**RE: HIDDEN HILLS SOLAR ELECTRIC GENERATING SYSTEM
APPLICATION FOR CERTIFICATION 11-AFC-02**

SUPPLEMENTAL

COMMENTS & ANALYSIS

SUBMITTED BY C.R. MACDONALD
JULY 2012

WATER SUPPLY - FIGURE 22
Hidden Hills Solar Electric Generating System (HHSEGS)

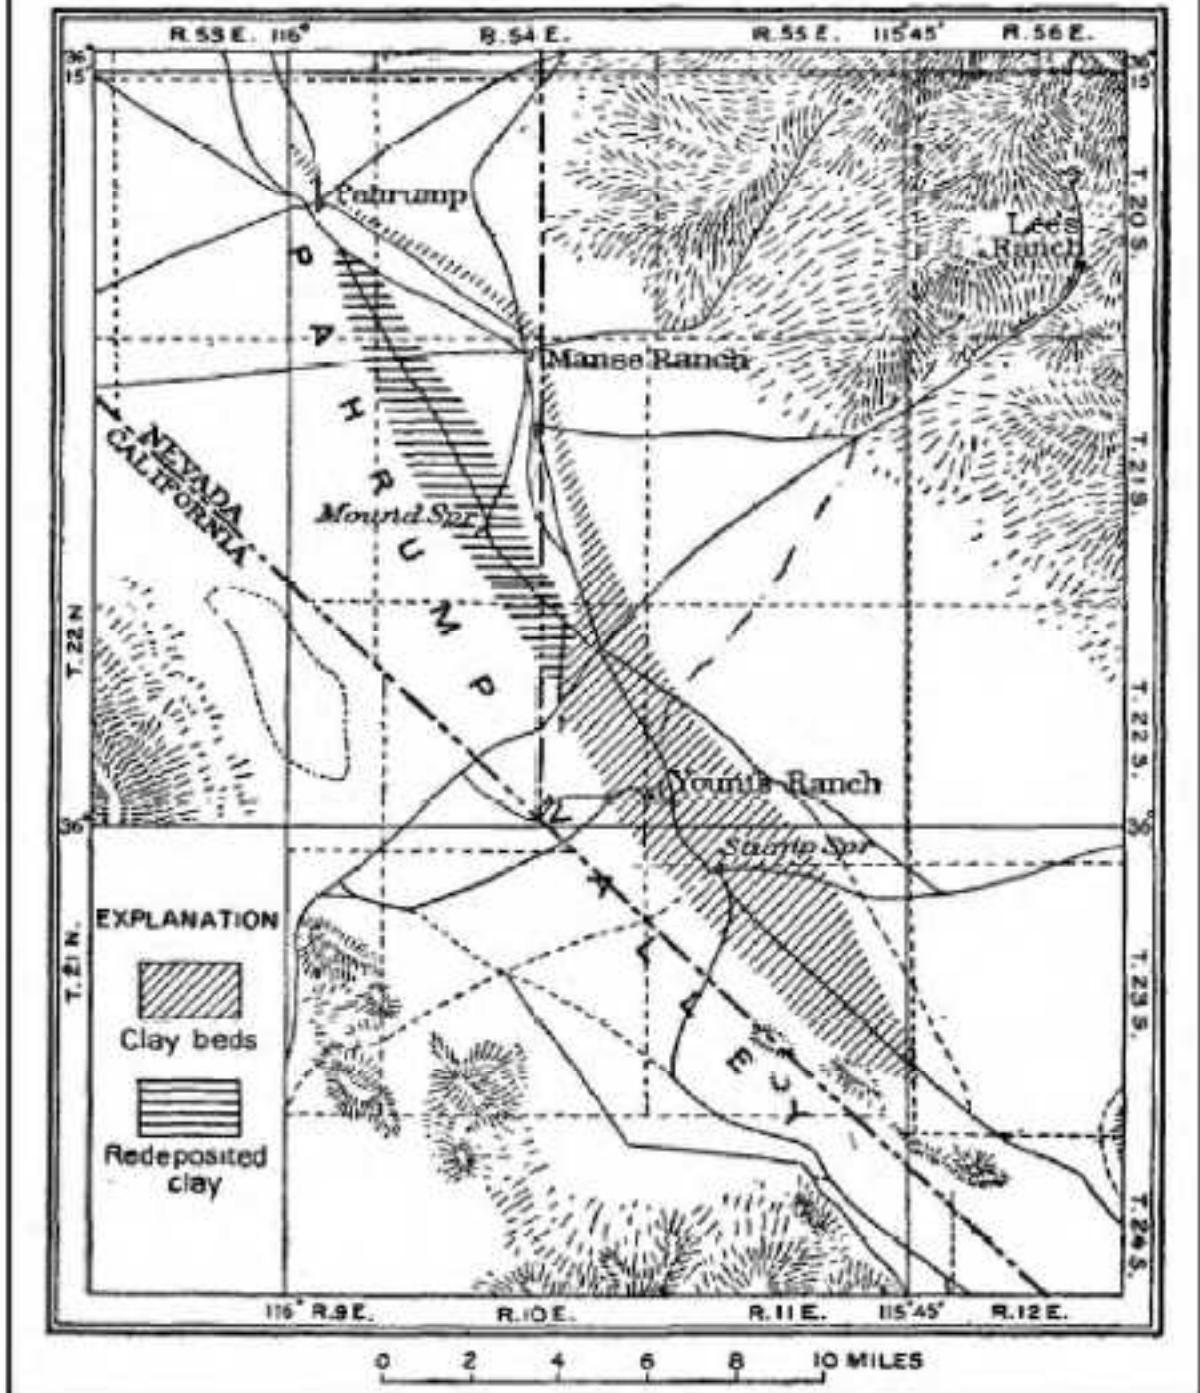
Additionally, the Preliminary Geotechnical Report compiled by the applicant in 2011 contained the most current data and evaluations available of soil properties related to the proposed project sites suitability. All of its key findings and warnings were ignored by the CEC Staff in the Preliminary Staff Assessment.

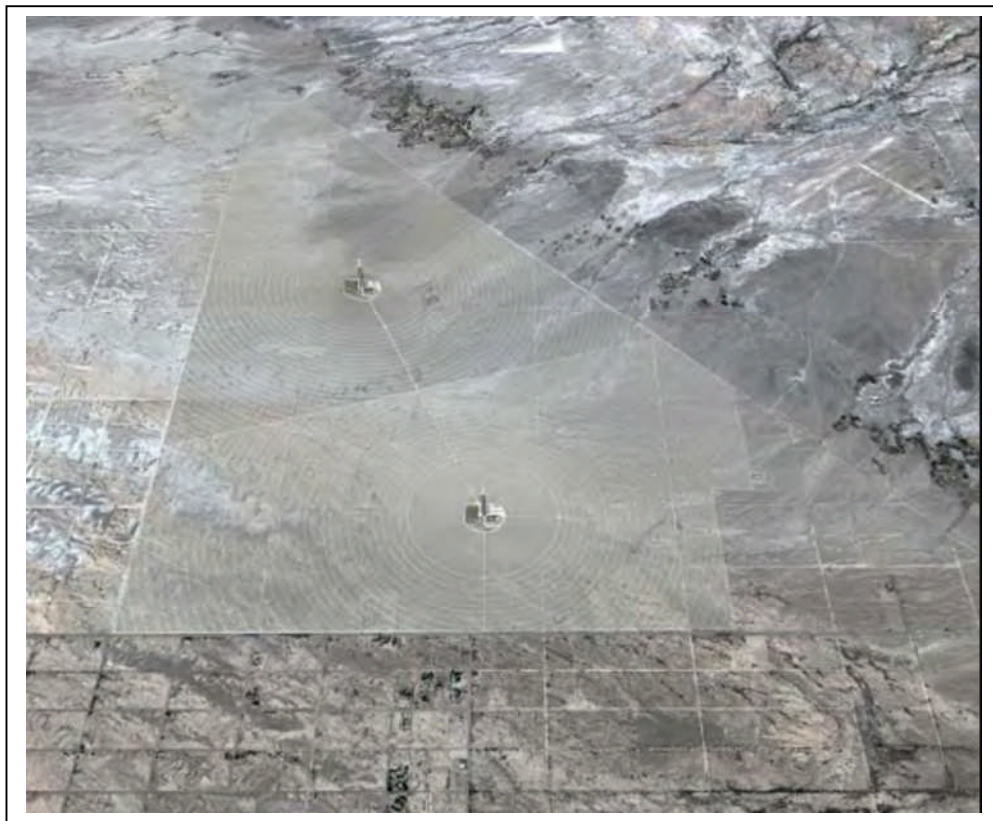
".....The analysis of the storm event and resulting heliostat stability will be provided within a Pylon Insertion Depth and Heliostat Stability Report to be completed by the applicant. This analysis will incorporate results from site-specific geotechnical stability testing, as well as hydrologic and hydraulic storm water modeling performed by the applicant. The modeling will be completed using methodology and assumptions approved by the CPM. The project owner shall also develop a Storm Water Damage Monitoring and Response Plan to evaluate potential impacts from storm water....."⁽²⁾ [Emphasis added.]

Of additional concern is Staff's conflicting description's of the value of modeling storm water impacts. First, they describe the modeling and calculations as *"based on assumptions and projections that are imprecise and untested in this environment"*. Staff then turns around and recommends modeling be completed to determine potential impacts and mitigation measures for the site, but again, only after project approval.

Source: HHSEGS Preliminary Staff Assessment, Soils and Surface Waters, Figure 3, pg. 611.

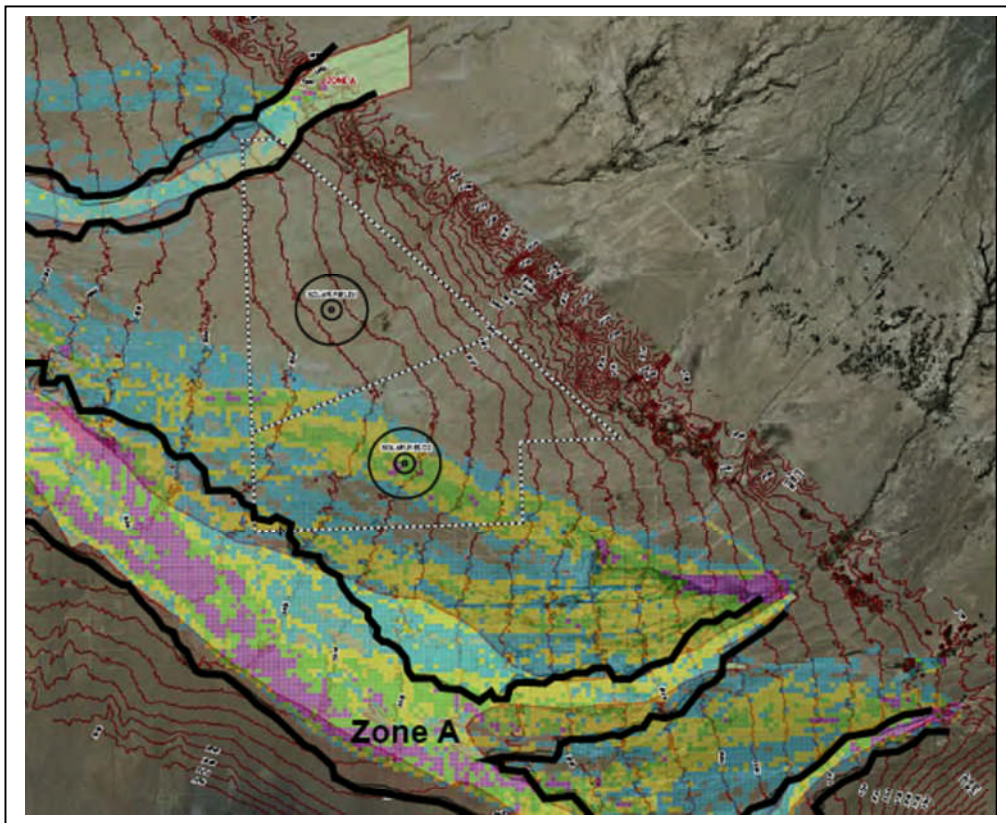
“Two areas, located at the north tip of the site and the southwest corner of the site (see Soils & Surface Water Figure 3) have been mapped by FEMA as Zone A, which means 100-year flood zone with no base flood levels determined. These are considered approximate flood zones.”⁽¹⁾ [Emphasis added.]

**TRANSMISSION SYSTEM/GAS PIPELINE
ALTERNATIVE ROUTE**

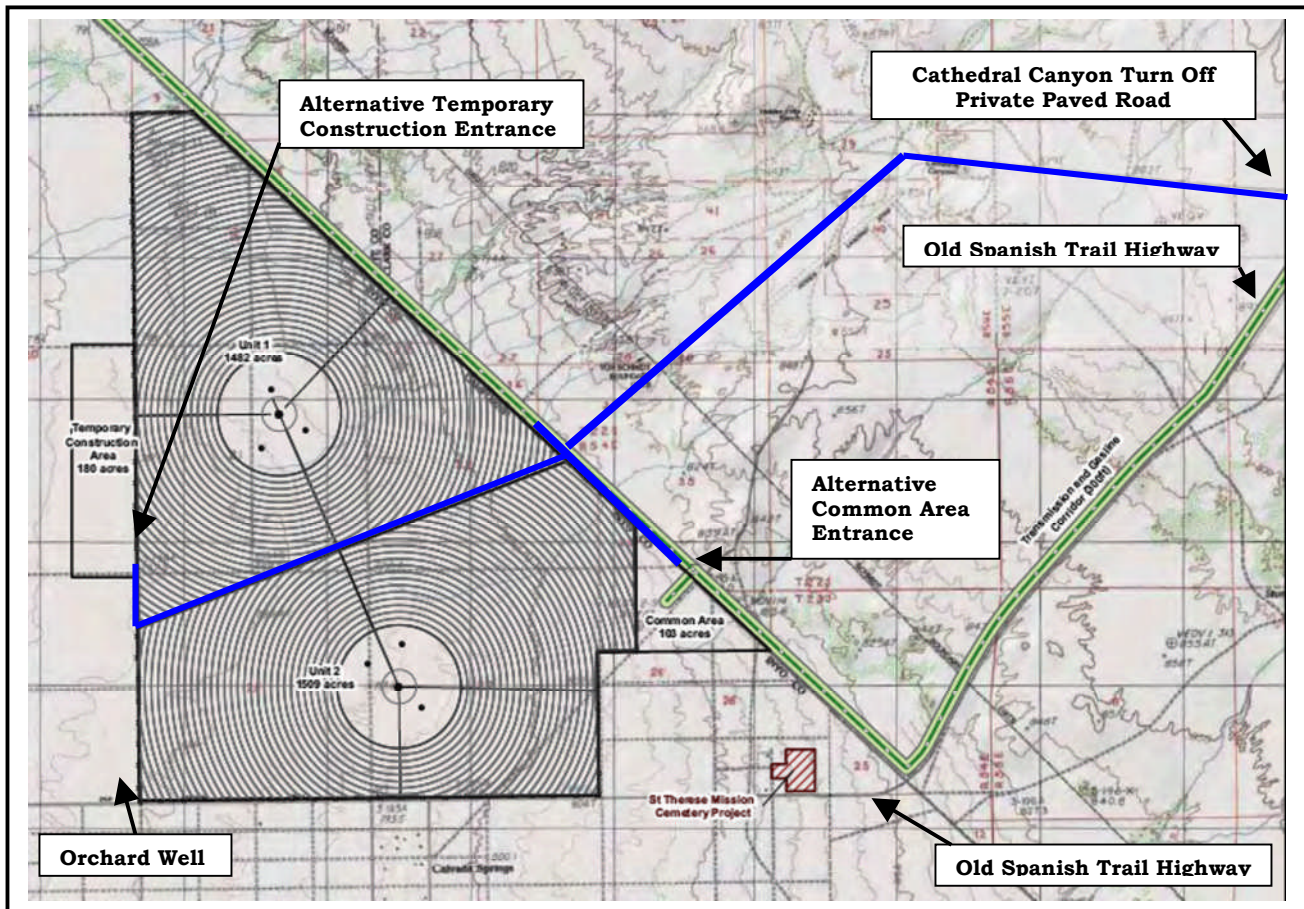
Instead of the transmission system and gas pipeline entering the site from the Old Spanish Trail Highway on the California side of the border, entry could also be obtained on the Nevada side of the Old Spanish Trail Highway at the juncture of a private road formerly used to access Cathedral Canyon. This road (shown right) is located 5.5 miles from Orchard Well and while not complete, could be developed to lead directly into the project site.

The road is owned and controlled by the same parties who are leasing the land to applicant and therefore, they have complete control to authorize the construction and maintenance of a private road to access the site.
